## Quality Assurance of Chapter 9: Definition of the Beltline

This report documents the results of the quality assurance task for Chapter 9 of the draft technical basis NUREG for the risk-informed Appendix G project. Chapter 9 discusses a more precise definition for the term "beltline." The quality assurance effort for this chapter involved three specific subtasks: (1) plotting axial fluence profiles for several reactor vessels, (2) verifying reference temperature shift calculations, and (3) verifying a check of the Reactor Vessel Integrity Database (RVID2) with license renewal application (LRA) data.

Figure 1: Axial fluence profiles for 3 BWR vessels, as determined during the QA work.

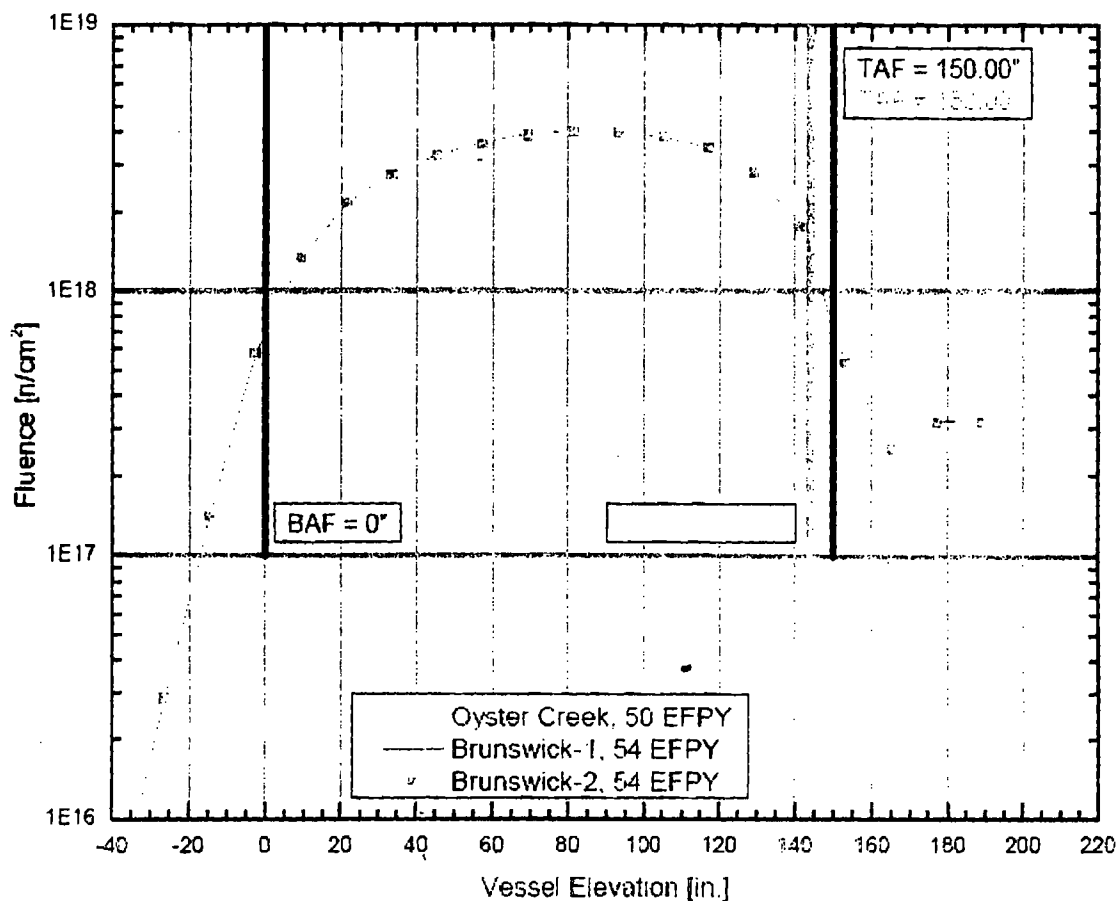
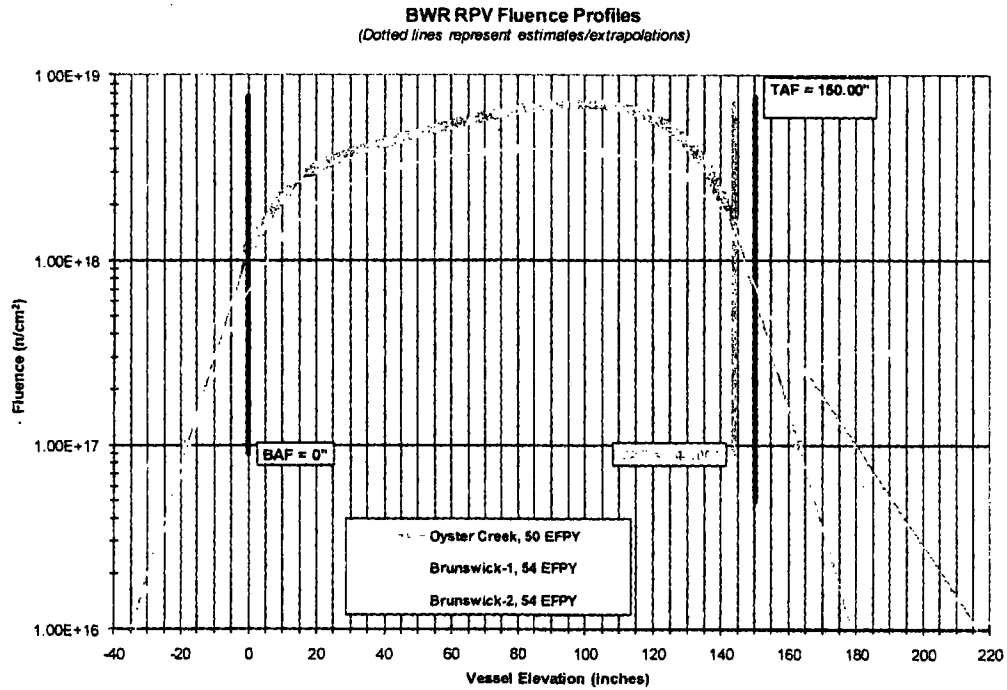
The fluence data was independently extracted from the sources used in the technical basis work. The boiling water reactor (BWR) fluence profiles obtained during the quality assurance (QA) work are shown in Figure 1, while the plots obtained during the technical basis (TB) work are shown in Figure 2. The corresponding plots for pressurized water reactors (PWRs) are shown in Figures 3 and 4, respectively. The figures show reasonable agreement.

Figure 5: Comparison of  $\Delta T_{30}$  calculations using two sets of input data, as determined during the QA work.

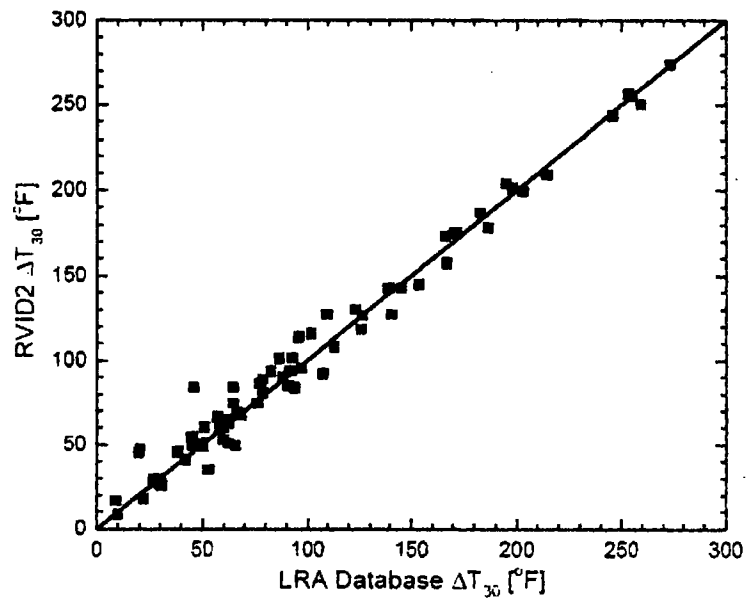
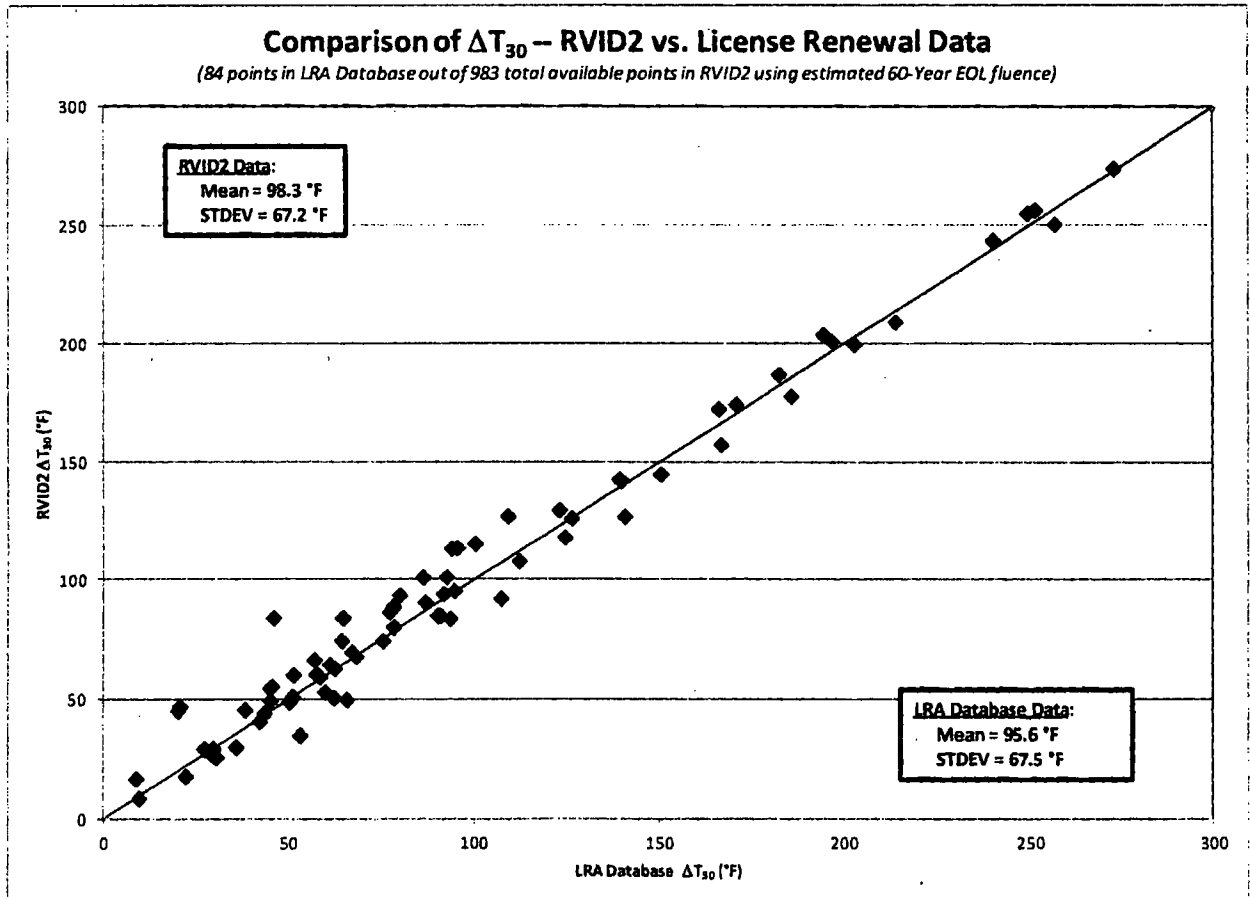
As part of the technical basis work for risk-informed Appendix G, the information contained in the RVID2 database was compared to data in LRAs. The purpose of this work was to verify that the RVID2 data was consistent with the latest data submitted in the LRAs. Reference temperature shifts (i.e.,  $\Delta T_{30}$ ) were calculated based upon inputs from both sources and the 10 CFR 50.61a method. The QA effort uncovered minor errors in the TB calculations of 1/4t fluence values for certain vessel locations. The corrected plots of RVID2  $\Delta T_{30}$  vs. LRA  $\Delta T_{30}$

obtained during the QA work and during the TB work, respectively, are shown in Figures 5 and 6.

Qualitatively, Figures 5 and 6 show reasonable agreement.
